Access Compliance Report
Public Rights-of-Way
(Curb Ramps)

Main Street: TIERNO_RD | **Cross Street: ANDAZA_ST** | **Location: S**

ADA ID: RPRK211129125208 | **Ramp Type:Type 1 - Perpendicular** | **Initial Pass/Fail: Pass** | **Overall Compliance: No** | **Severity Score: 2**

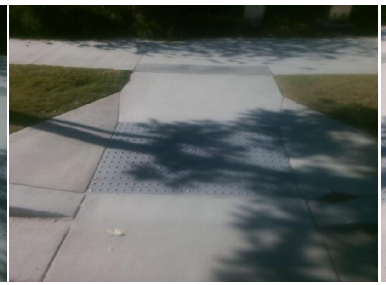
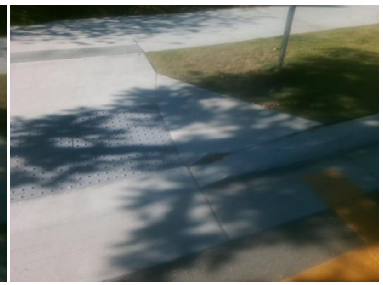
Remove & Replace Curb Slope.

R304.2.2, STD 1115
